A G E N D A

Architectural Review Board

June 28, 2016

Side View

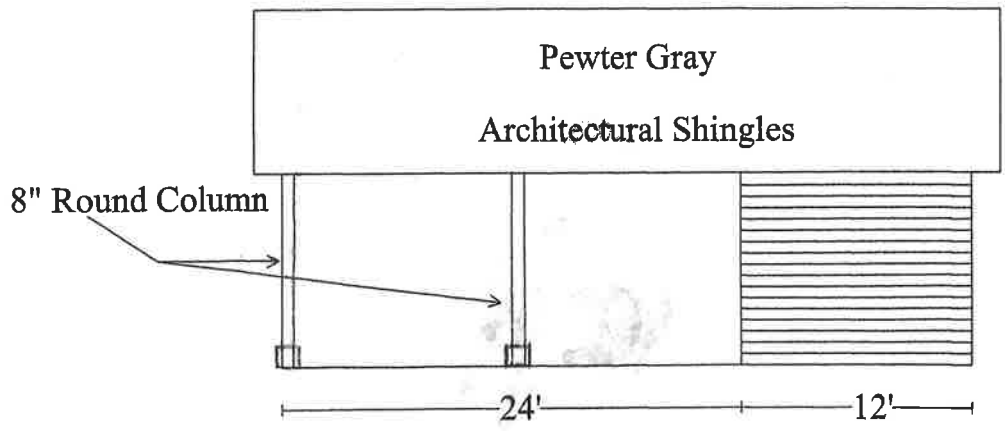
- This is a corner lot.
- The Board has approved carport/accessory structures that were compatible with the style of the house, and appropriately scaled to the house.
- No objection on the tree removal.

PORCHES

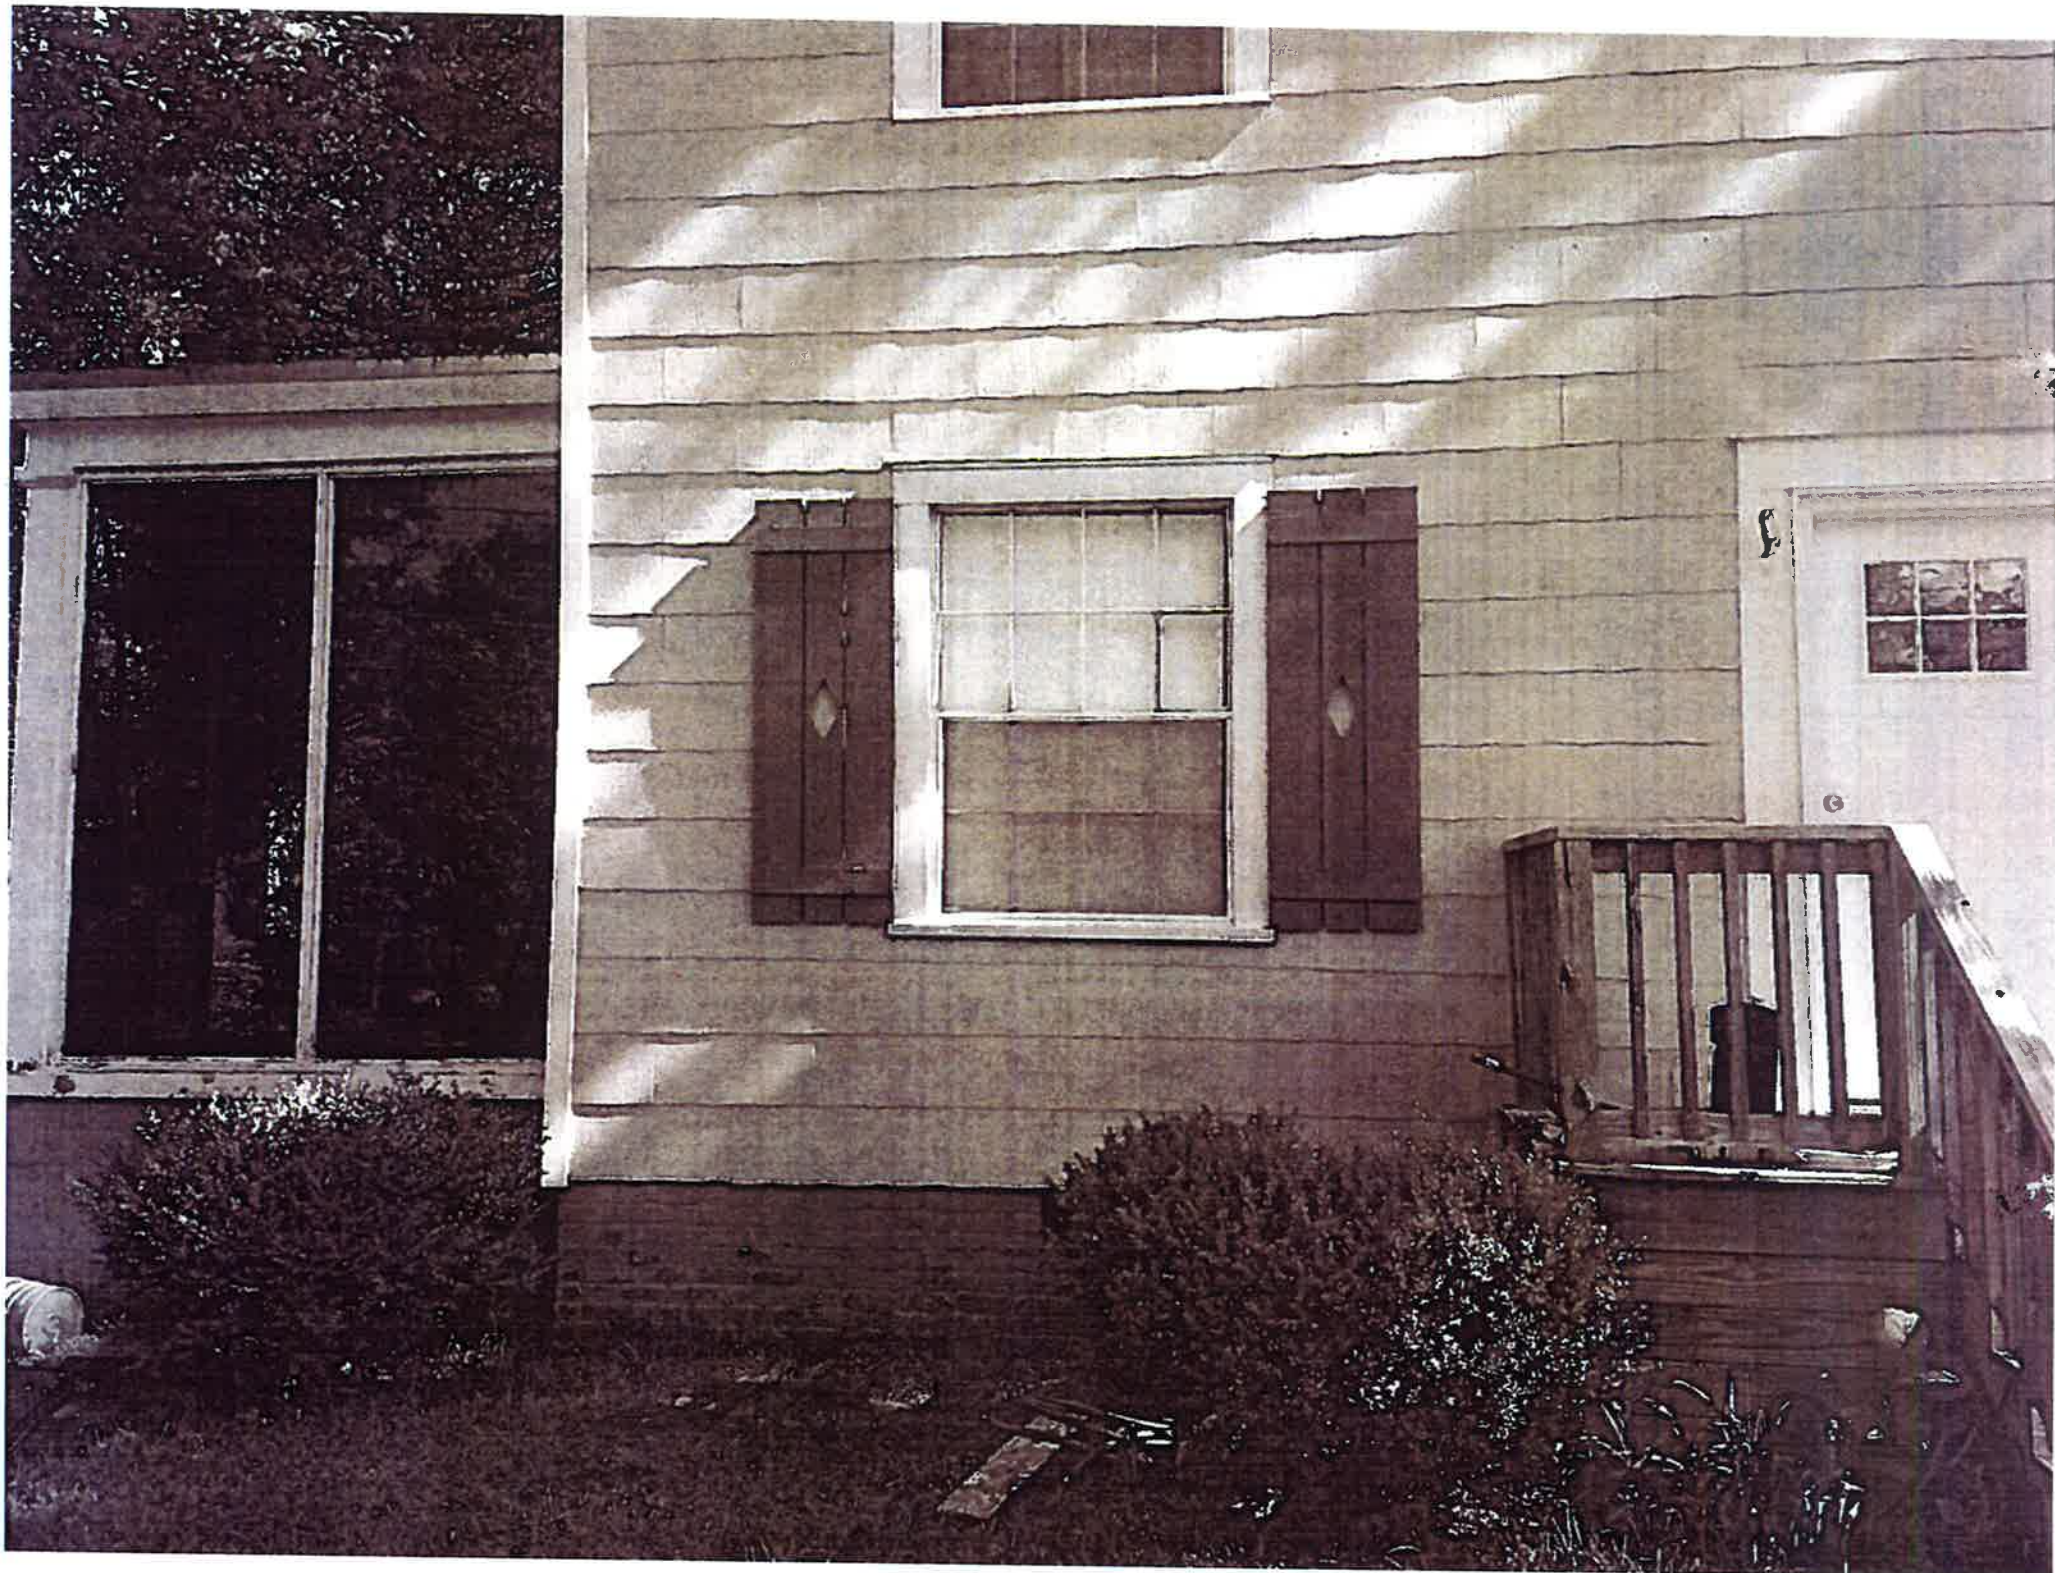
- The Board has asked for a vegetative screen for areas wider than a single car to soften the appearance of the additional hardscaping when there was concern that the additional width would detract from the appearance of the structure and/or streetscape.

REAR ELEVATION REVISED

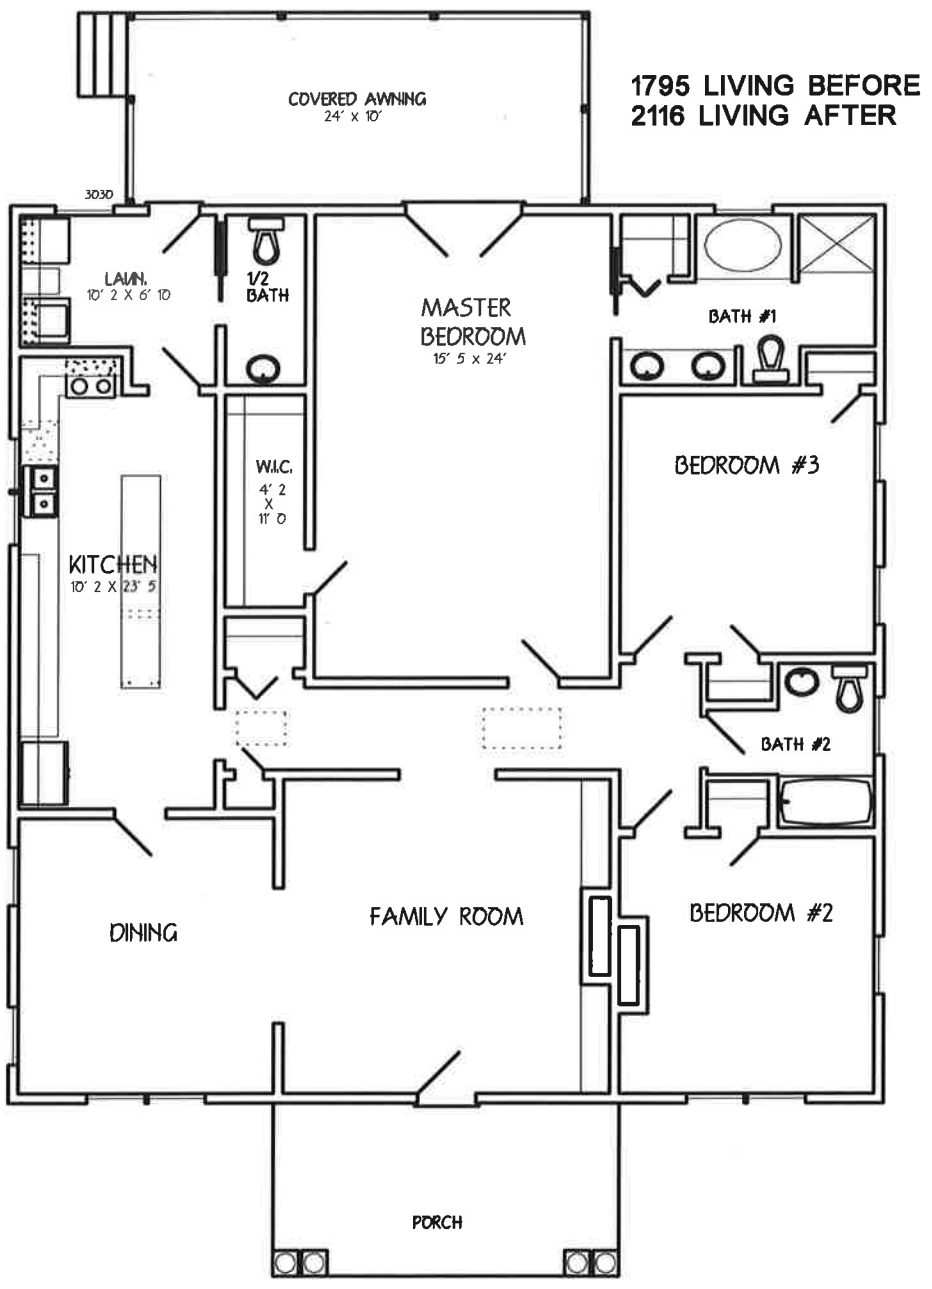
- The Urban Forester observed the tree on the ground after it was cut and before it was removed. The tree was sound with no signs of decay. In response to the supplied letter, limbs broken in a thunderstorm event do NOT indicate hazardous conditions.
- The new rear door and windows need to be specified.
- If the project is approved and the owner has no use for the windows and door being removed (if they are not fire damaged), staff recommends the window be given as a tax deductible donation to Rescued Relics, operated by Landmarks Foundation of Montgomery. For information call 240-4512.

option 1

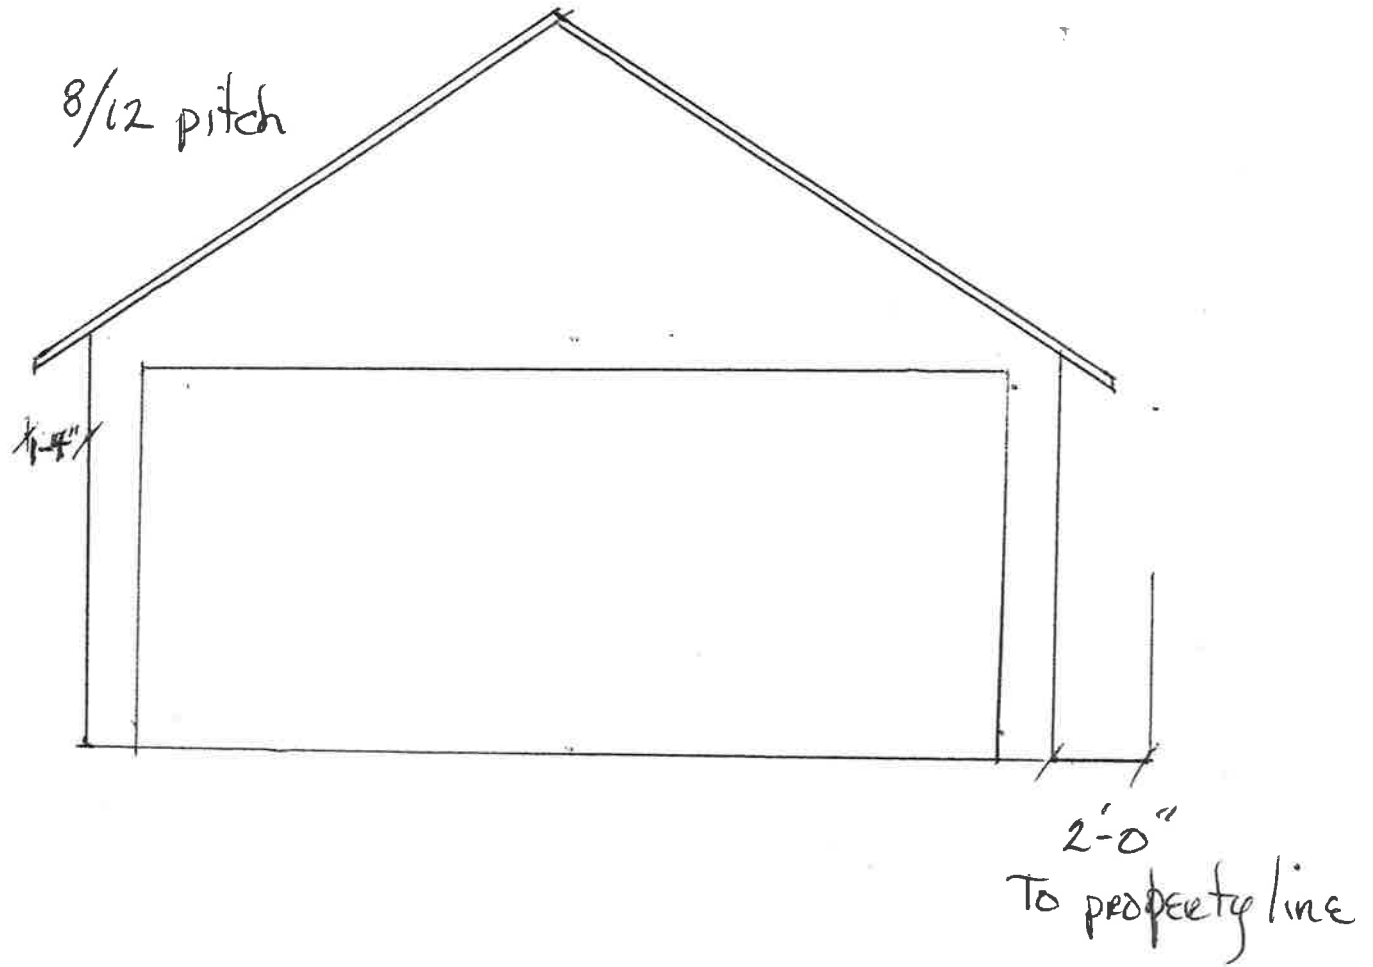
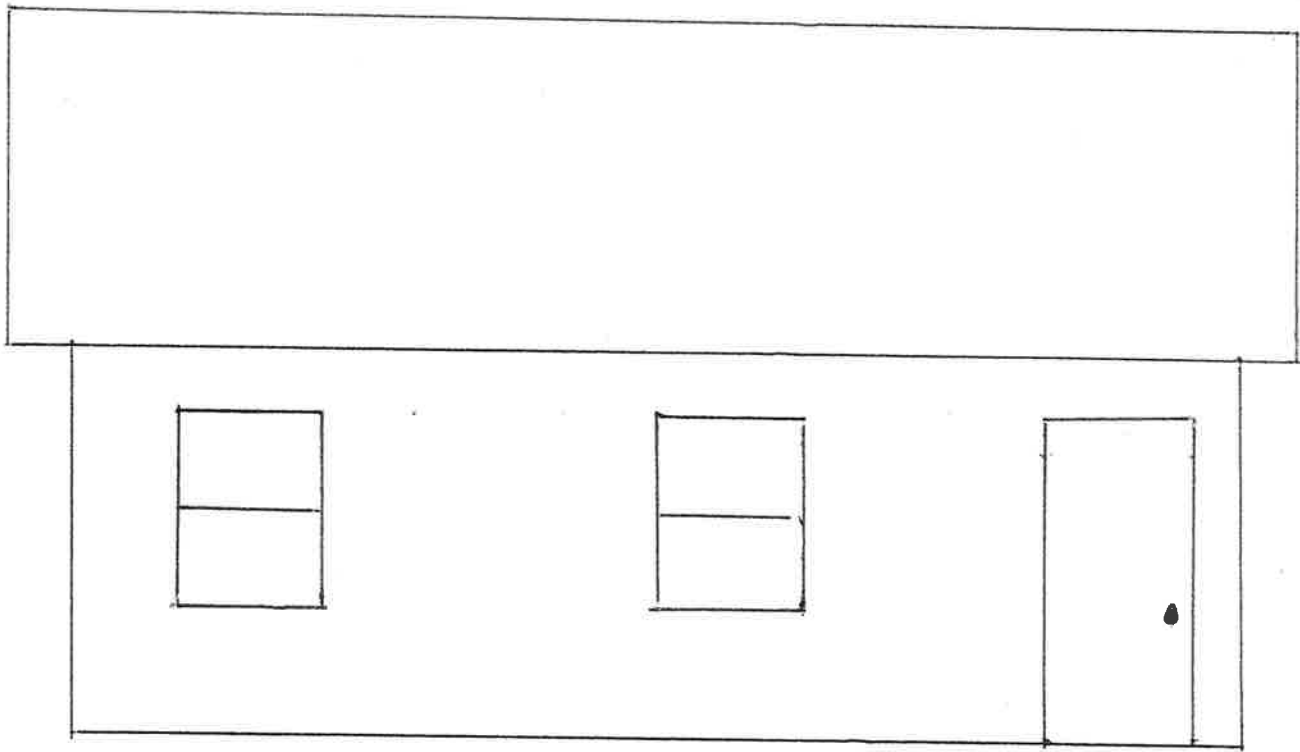
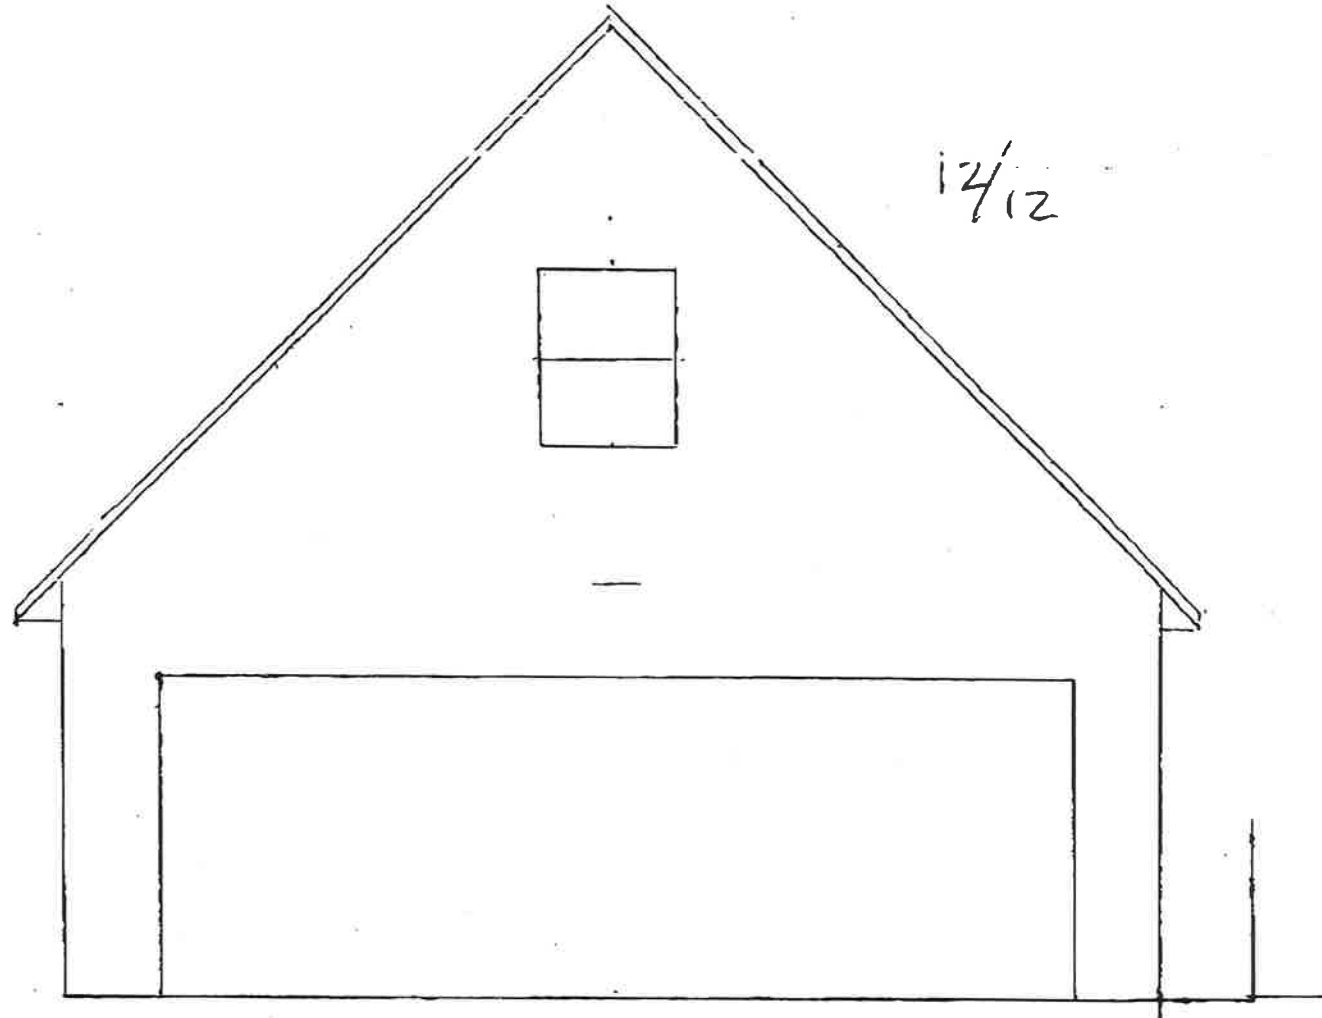
The application specified vinyl windows, the owner has been advised those windows would not be acceptable and that a wood window would probably be the most cost effective replacement (versus a double paned window). The window will either be a 1:1 wood window, or an alternate salvaged window will be presented at the meeting.

- A setback variance is required from the Board of Adjustment for the side and rear property line as the proposal brings the structure closer than 5'.
- Windows need to be specified, the Board has approved steel walk through and car doors for outbuildings.
